**ADDENDUM NO. 03**  
February 12, 2010

Project: **Dickinson High School Additions and Renovations**  
Dickinson Independent School District

Bay Project No.: 0743

**ADD-03-22**  
 0743  
 SCALE: 1/8" = 1'  
 02/12/2010  
 P3.08

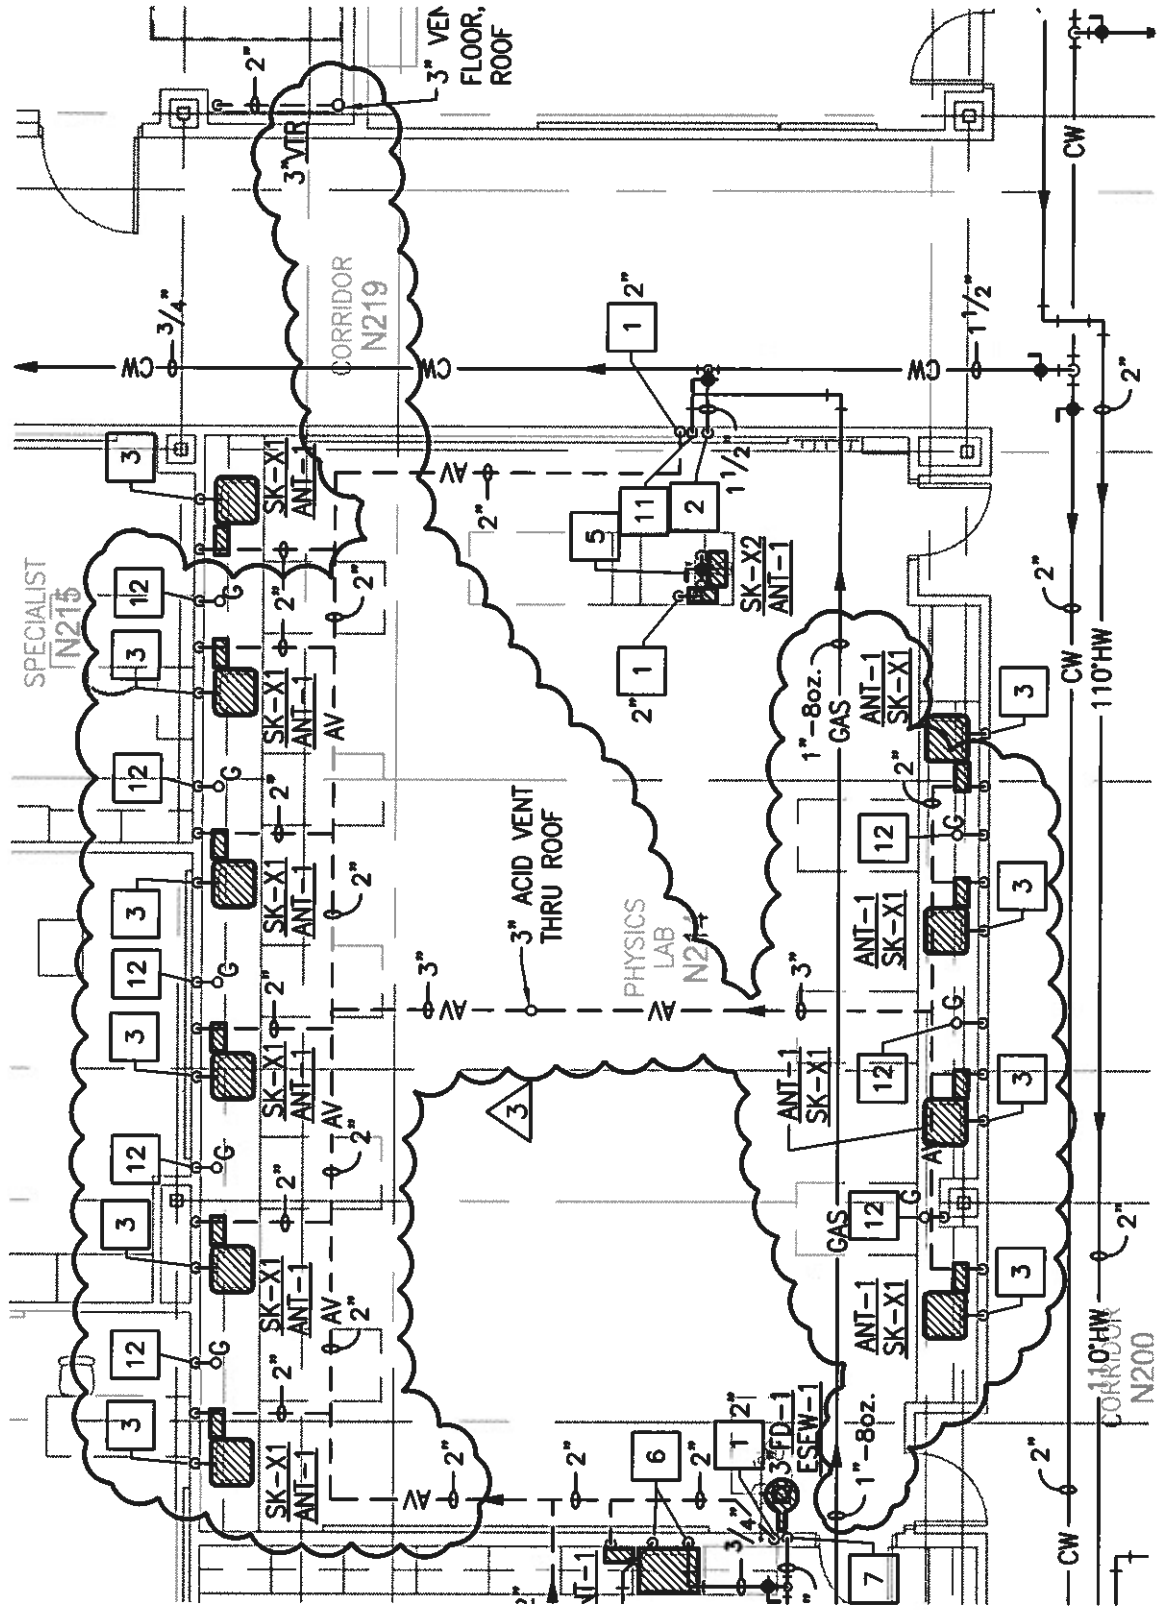
54. Sheet P3.08 – Plumbing Plan Second Floor – Unit N - Area 'D'
- Revise drawing to indicate proper matchline and eliminate plumbing work shown beyond the matchline limits. . Refer to Sketch **ADD-03-22**.

**ADD-03-23**  
 0743  
 SCALE: 1/8" = 1'  
 02/12/2010  
 P3.10

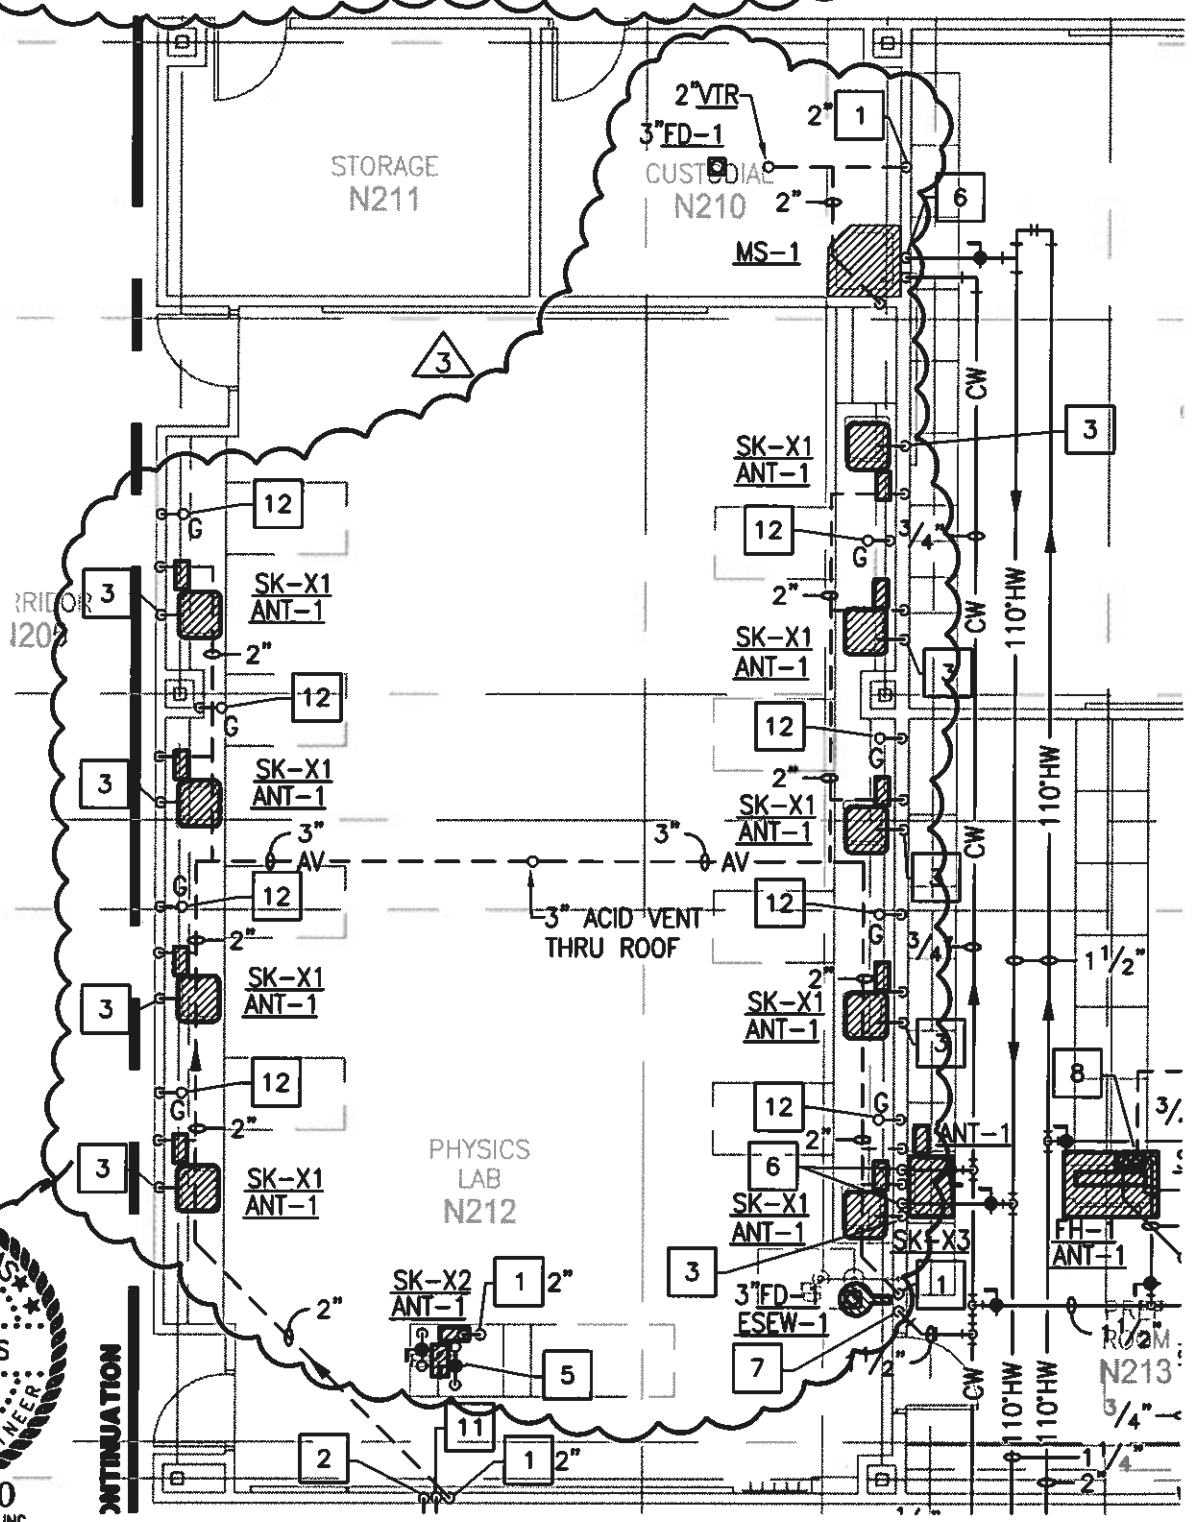
56. Sheet P3.10 – Plumbing Plan Second Floor - Unit N - Area 'E'
- Physics Lab N214 - Create acid Vent system eliminating piping connection to Sanitary Vent above Corridor N219. Add new 3" Acid Vent thru roof for Acid Vent piping serving the area. Route 1/2" gas up thru floor, into casework to gas turret serving Student Lab Station. Re: Sketch **ADD-03-23** and Sheet A8.02.

<b>DICKINSON HS ADDITIONS &amp; RENOVATIONS</b>	<b>ADD-03-24</b>
DICKINSON I.S.D.	0743
	SCALE: 1/8" = 1'
	02/12/2010
	P3.10

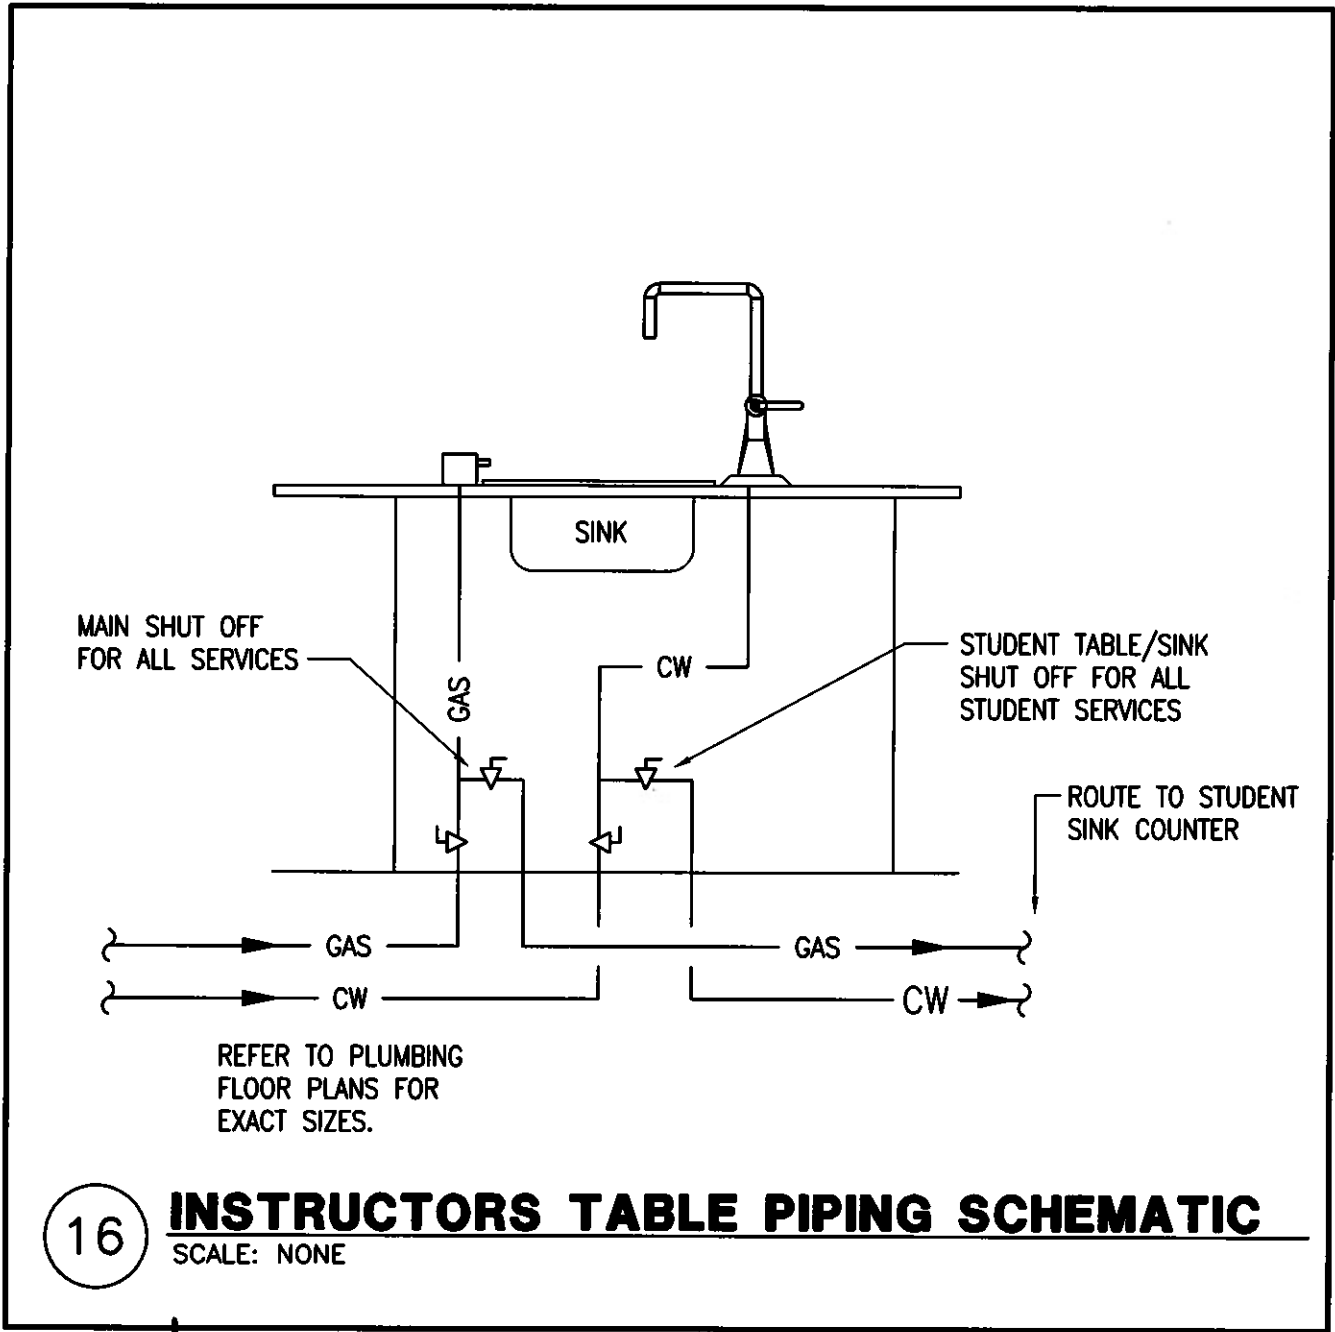
- b. Physics Lab N212 - Create acid Vent system eliminating piping connection to Sanitary Vent above Corridor N205. Add new 3" Acid Vent thru roof for Acid Vent piping serving the area. Route 1/2" gas up thru floor, into casework to gas turret serving Student Lab Station. Re: Sketch **ADD-03-24** and Sheet A8.02.

- c. Revise key note number 11 from 3/4" to 1". Add key note 12. . Re: Sketch **ADD-03-24**.
57. Sheet P3.13 – Plumbing Plan First Floor – Unit N - Area 'G'
